BDR SONATA WEST
4561 MARTIN LUTHER KING WAY S

DESIGN REVIEW
REVISIONS

SDCI# 3017381
APRIL 12, 2016

DEPARTURE #1: SMC 23.47A.014.B.1 CORNER SETBACK

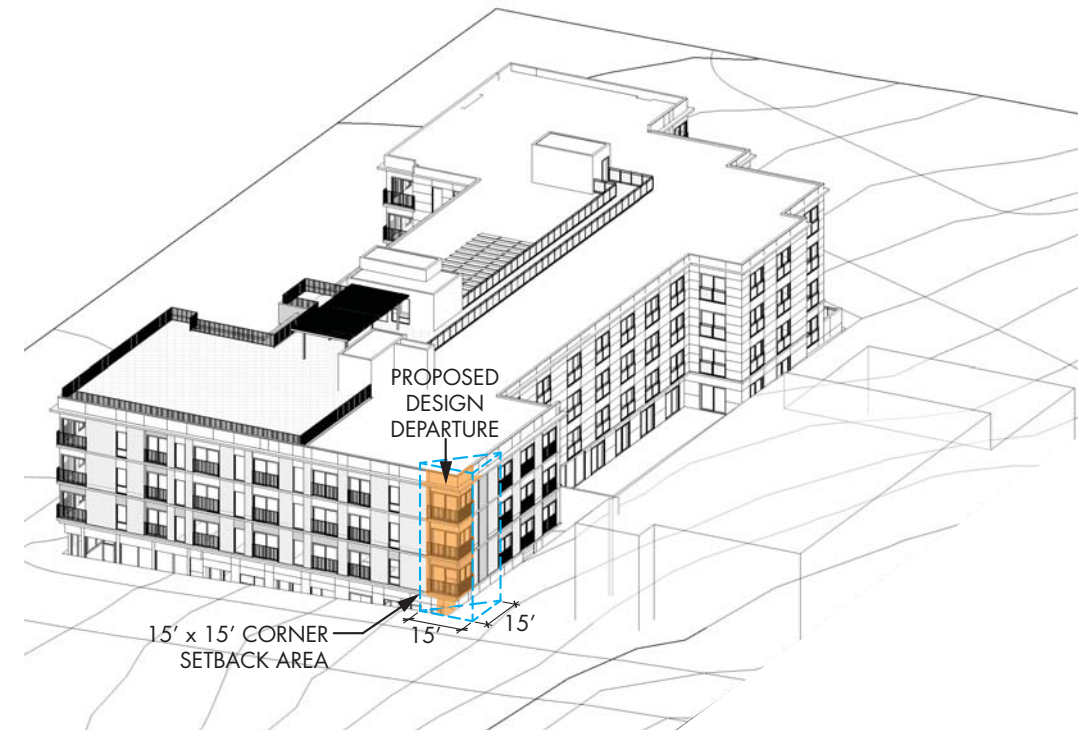
The Board agreed that the driveway does offer a buffer.

Request: 7'-0" by 7'-0", for the upper stories.

Rationale: The shared driveway between the proposed structure and the existing residential structure on the west provides the required buffer between zones.

DEPARTURE # 3: SMC 23.54.D.1.c - DRIVEWAY WIDTH

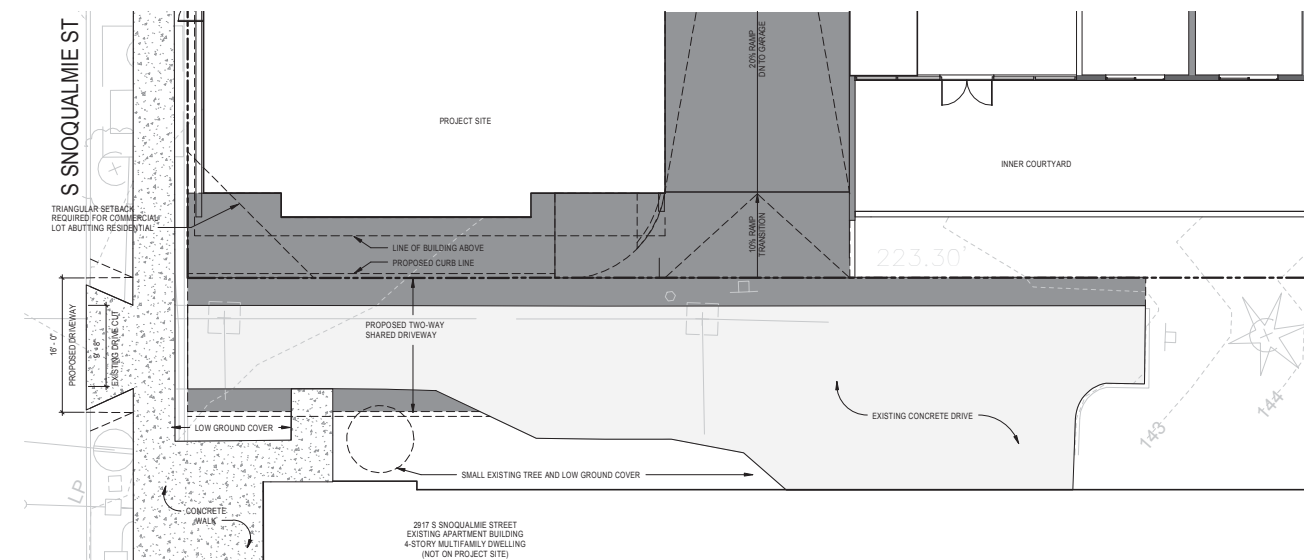
The Board concurred with the shared driveway approach during EDG and the design was carried over and presented during the first DR meeting. The Board agreed that the driveway would be a good solution in terms of safety and amount of curb cuts along S Snoqualmie St.

Proposed: A 16' wide shared access easement with the neighbor to the west.

Rationale: However allowing for landscaping, the access from the west will be slightly narrower than code allows. The benefit is a single curb cut for two projects and increased pedestrian safety across an established pedestrian corridor.

REQUESTED DEPARTURE CALCULATION

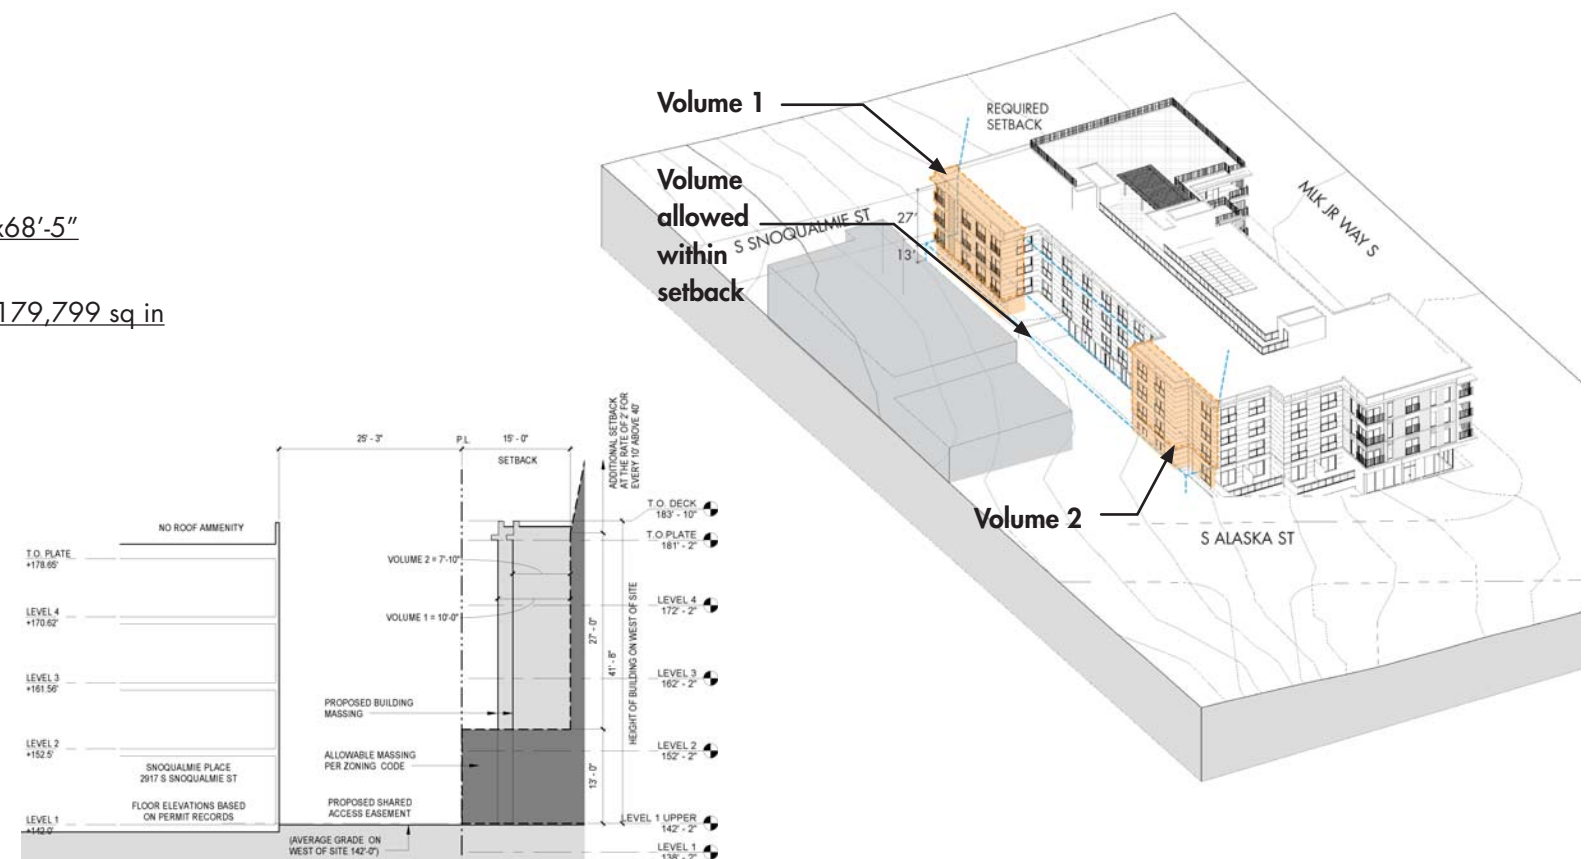
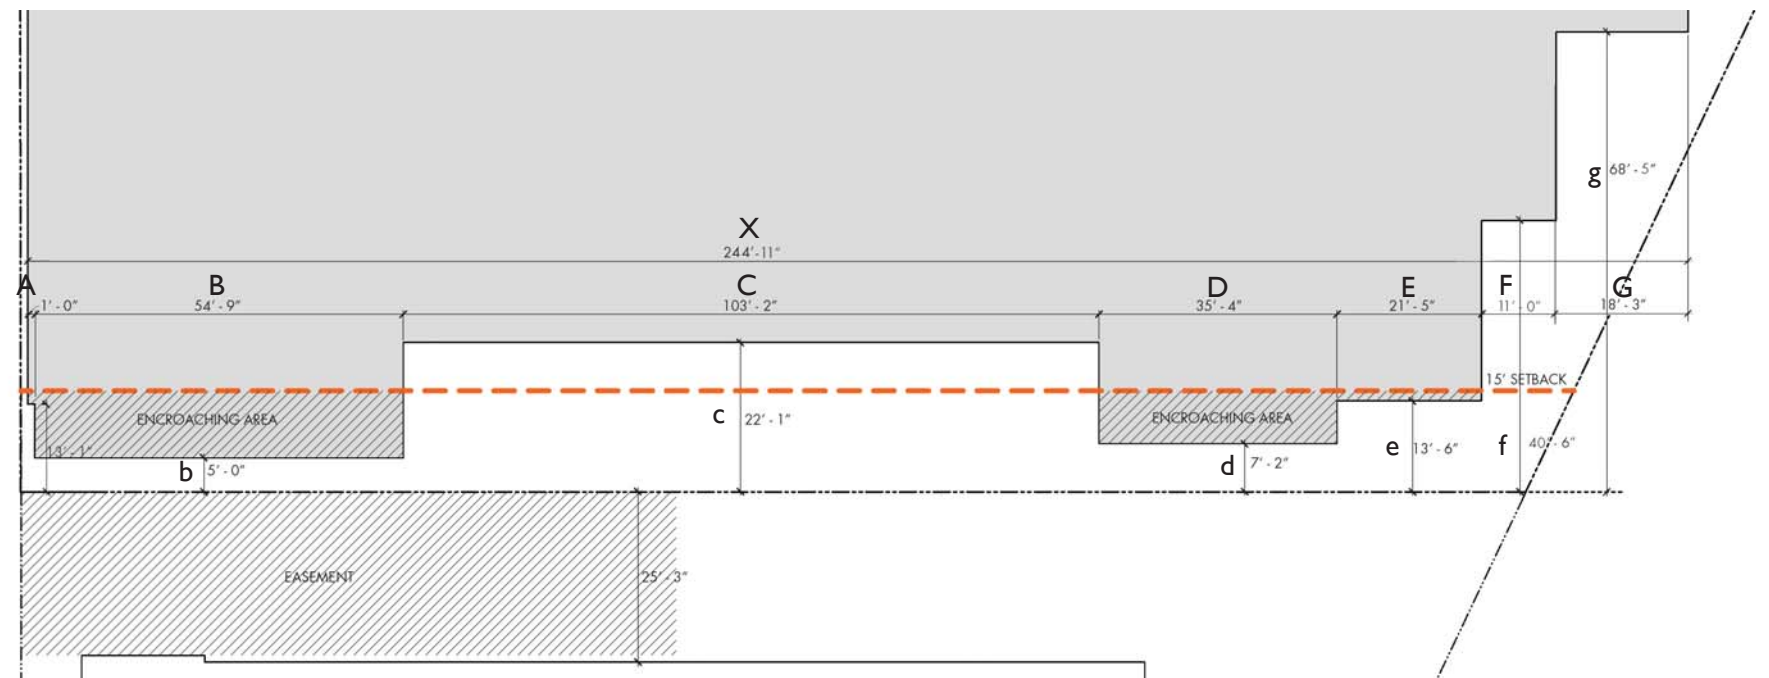
The Board requested better calculations of the proposed departure. The calculations below demonstrate the average setback and volume of the proposed project exceeds the average setback of 15'-0" above 13'-0" and volume-wise, it occupies less space than the code allowable volume within the same space.

$$\begin{aligned} \text{AVERAGE SETBACK} &= \frac{A \times a + B \times b + C \times c + D \times d + E \times e + F \times f + G \times g}{X} \\ &= \frac{1'-0" \times 13'-1" + 54'-9" \times 5'-0" + 103'-2" \times 22'-1" + 35'-4" \times 7'-2" + 21'-5" \times 13'-6" + 11'-0" \times 40'-0" + 18'-3" \times 68'-5"}{244'-11"} \\ &= \frac{1,884 \text{ in sq} + 39,420 \text{ in sq} + 328,070 \text{ in sq} + 36,464 \text{ in sq} + 41,634 \text{ in sq} + 63,360 \text{ sq in} + 179,799 \text{ sq in}}{2,939"} \\ &= \frac{690,631}{2,939"} \\ &= 234.99" = 19'-7" \end{aligned}$$

VOLUME ALLOWED BY CODE WITHIN SETBACK = 15'-0 x 13'-0" x 223'-4" = 43,550 cu ft

VOLUME PROPOSED IN REQUIRED SETBACK = Volume 1 + Volume 2
= (41'-8" x 54'-9" x 10'-0") + (41'-8" x 35'-4" x 7'-10")
= 22,813 + 11,533 = 34,346 cu ft

VOLUME PROPOSED IN REQUIRED SETBACK IS 9,204 cu ft LESS THAN VOLUME ALLOWED BY CODE

DEPARTURE # 4: SMC 23.47.005 - RESIDENTIAL USES AT STREET LEVEL

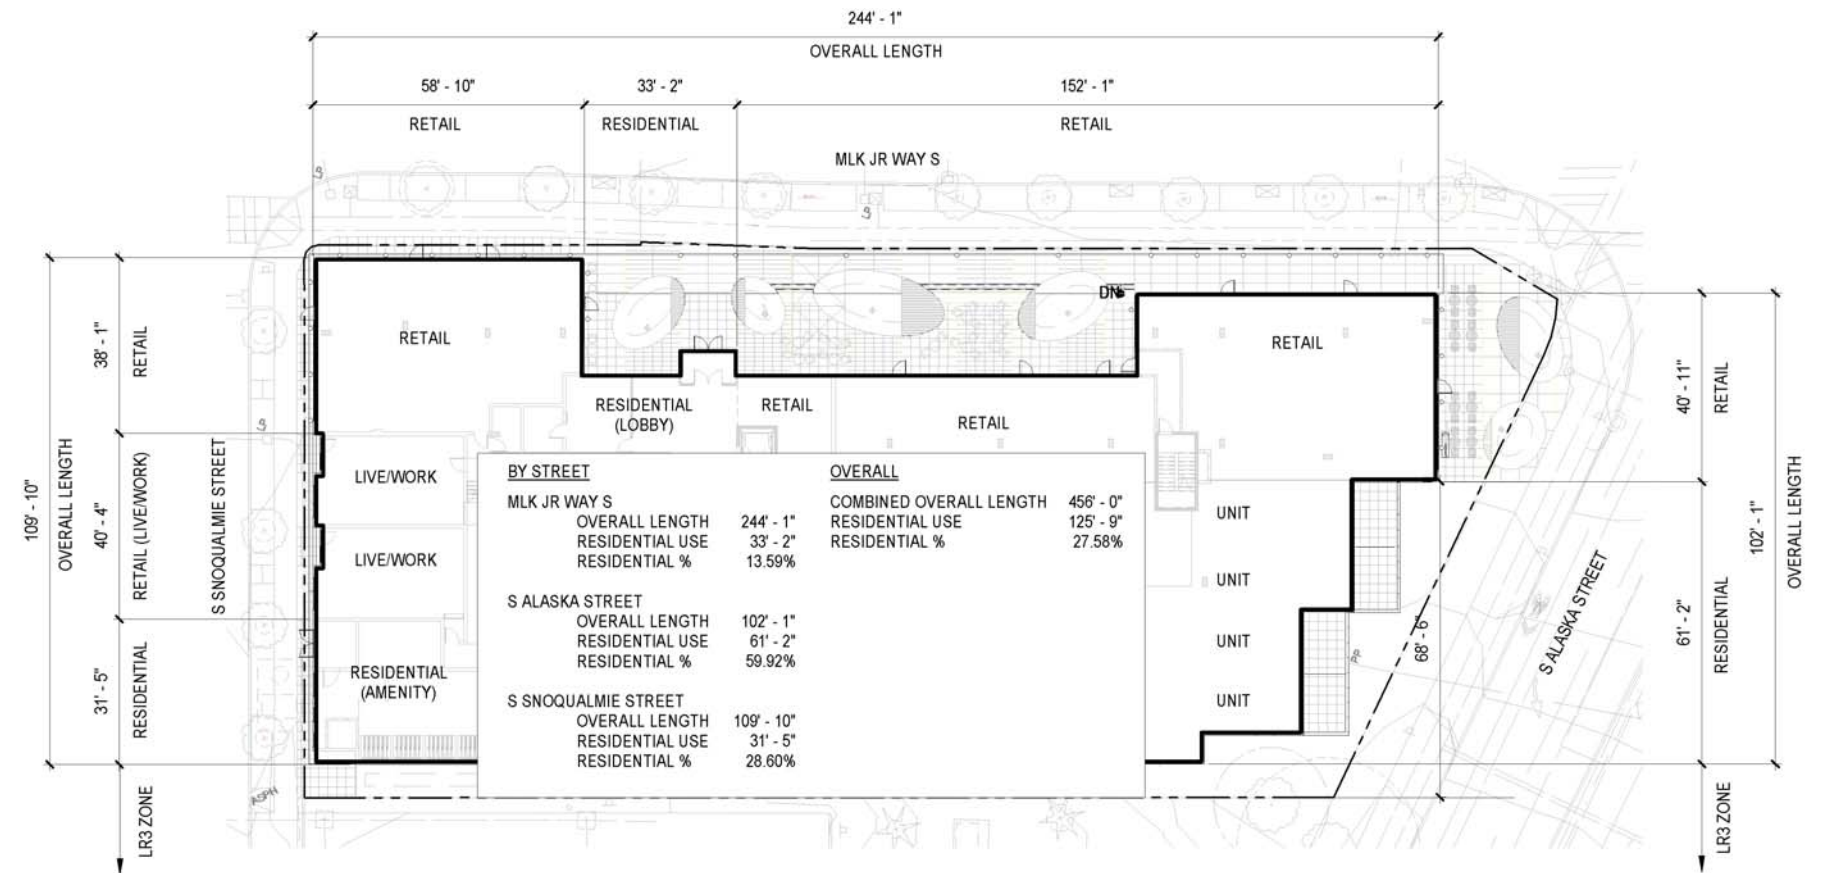
The Board recommended that the S Snoqualmie St elevation at street level needed further refinement. We added canopies and signage to highlight the commercial aspect of the live/work units and a whimsical bike room entry for the residential portion of this north facing facade.

Proposed: The applicant is proposing residential uses to occupy, in aggregate, 27.5% of the total street-level street-facing facade of the three streets surrounding the project.

Rationale: The proposed residential will provide a gradual transition of program from the commercial NC-1 zone to the neighboring LR-3 residential uses.

TRASH ACCESS

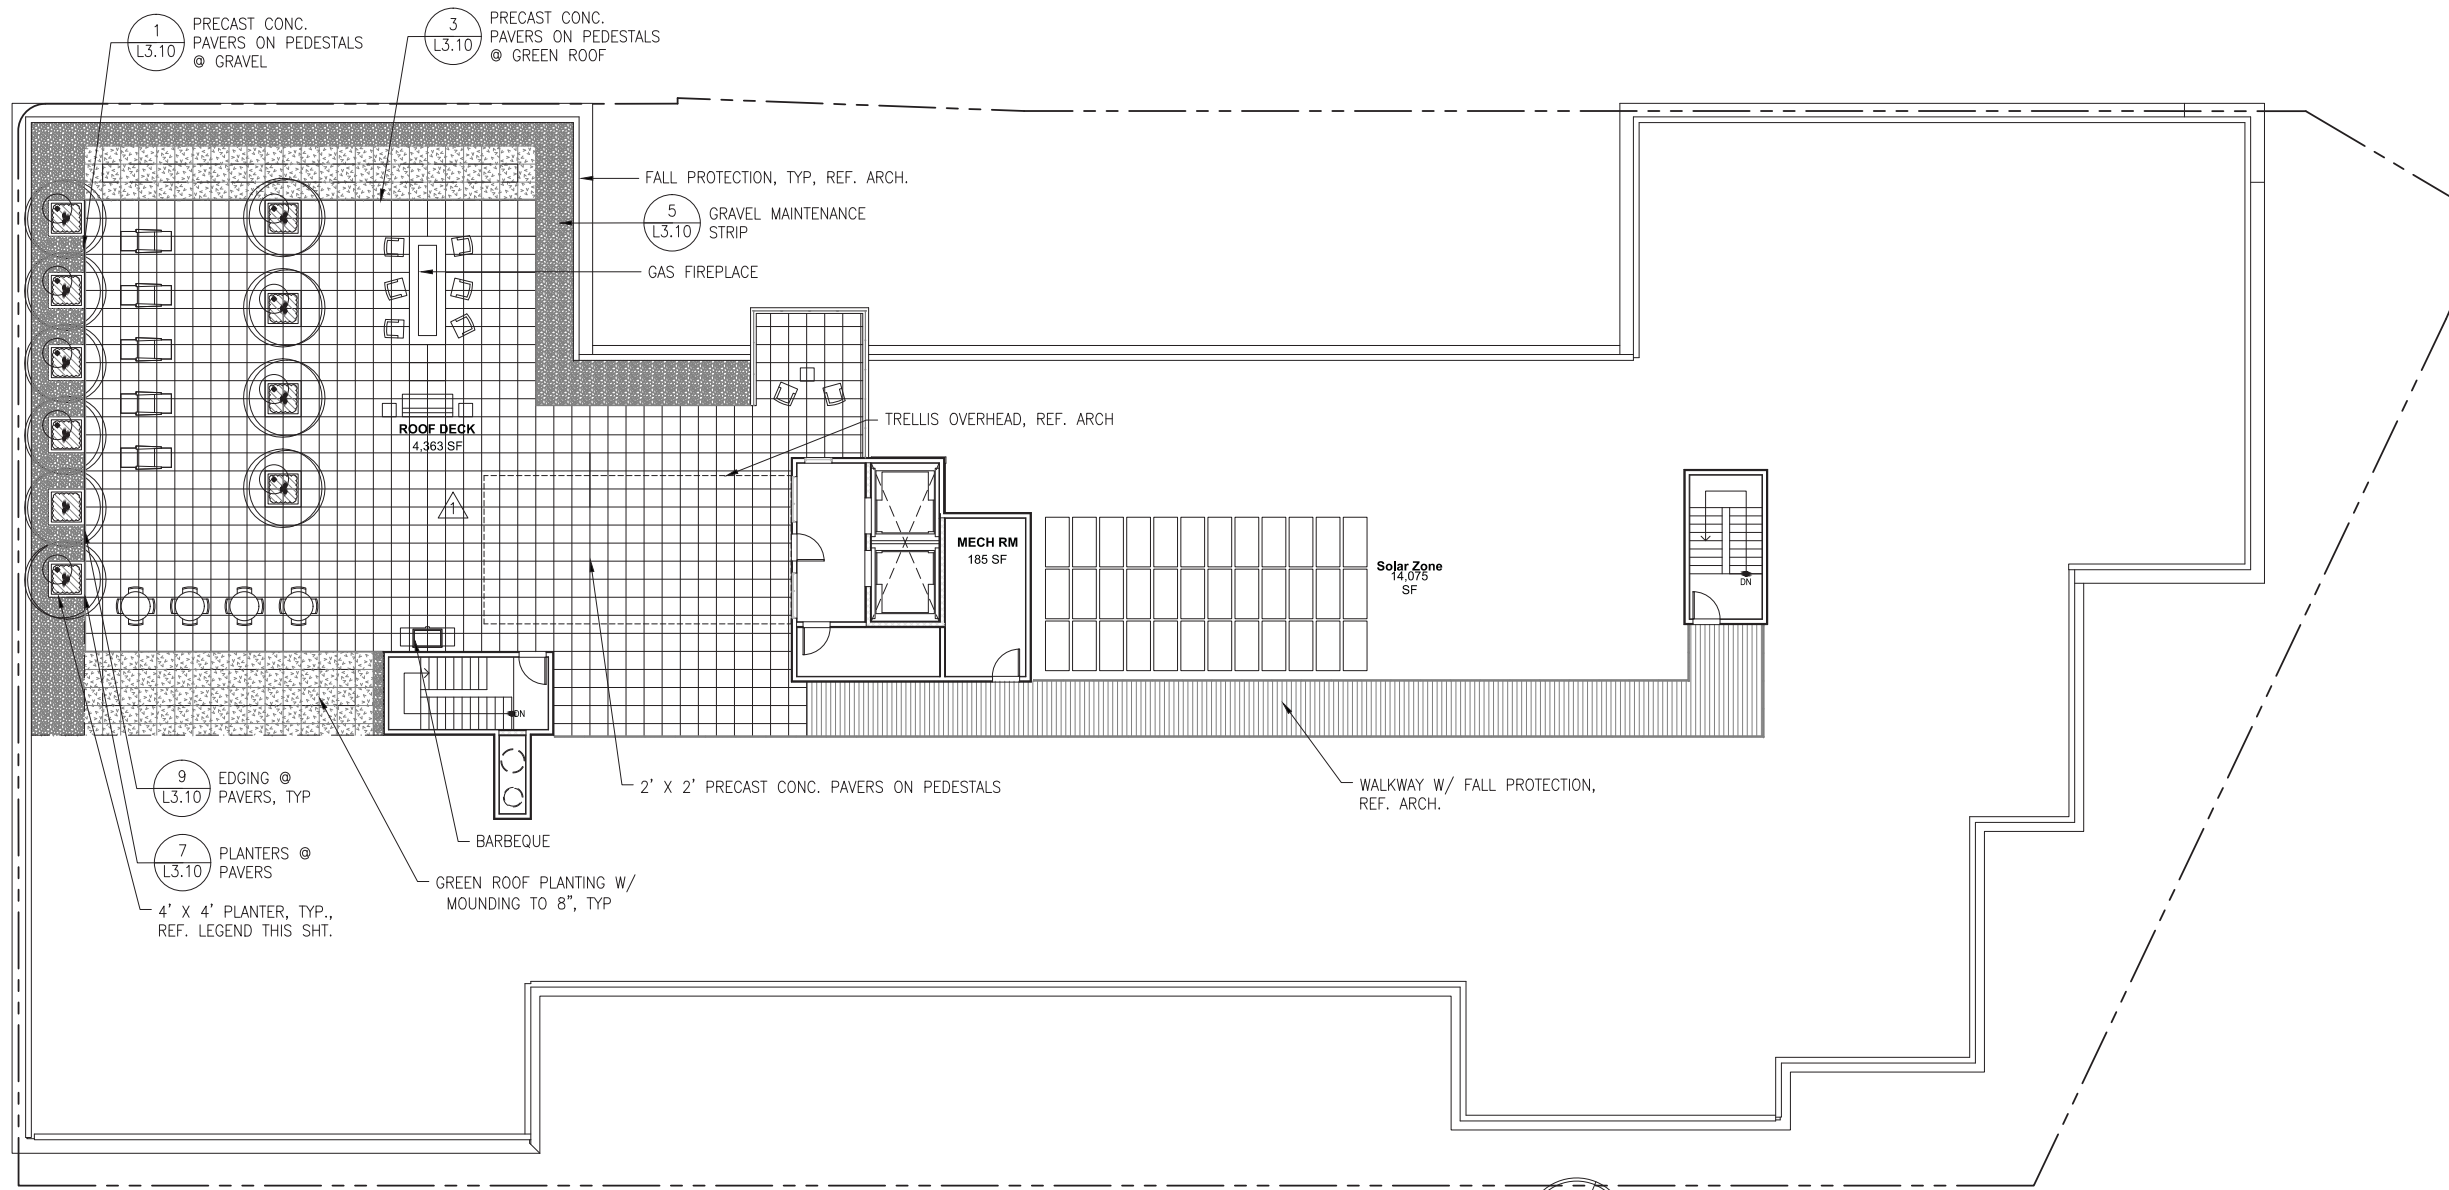
At the Design Review Meeting, the Board expressed concern that the trash room was not easily accessible for the retail space located at the south east corner of the project. It was noted that no back of house hall to the trash room was available, and retailers only access would be either through the interior residential lobby or on the sidewalks around the building.

The movement of trash is a part of the urban environment, is not regulated by either code or design guidelines, and no specific user has been defined for the retail space in question. While we are proposing infrastructure now, that would be almost impossible to add later, to accommodate a restaurant, to date there have been no inquiries regarding a restaurant use.

We have addressed the public comments on the related project by eliminating the option for taking retail trash through the residential lobby, and made the trash room more accessible by way of a pedestrian door from the shared access drive. We propose a similar solution here. To the greatest extent possible, the retail tenants pathway to the trash room has been diverted away from residential uses and completely diverted from interior spaces. There are no feasible means of creating direct access to trash for each retail tenant in that all solutions reduce the desired functionality of the building, including: reductions in parking, reductions in retail or residential area, and interference with the seamless connectivity between the residential and retail tenants that we have strived to create.

The condition as stated by the board is tied to Design Guideline DC1-A, Arrangement of Interior uses. The board's condition specifically request that the team review the interior configurations with the trash. Both "flexibility" and "views and connections" have been addressed to serve the greatest number of users for the greatest number of interactions. One trash trip a day is merely a part of the urban fabric, not a cumbersome interference.

We have provided a safe, accessible trash enclosure that accommodates the greatest benefit to the most tenants. To the benefit of the neighborhood, we have created a building that is either physically or visually porous on all sides in order to provide a better experience on all three streets, the shared driveway and to existing pedestrian movements, as well as a central circulation core that connects tenants to retail and residential amenity to the public amenity with clarity and grace. This should be celebrated and not punished for the relatively minor service needs of 2400sf of retail.
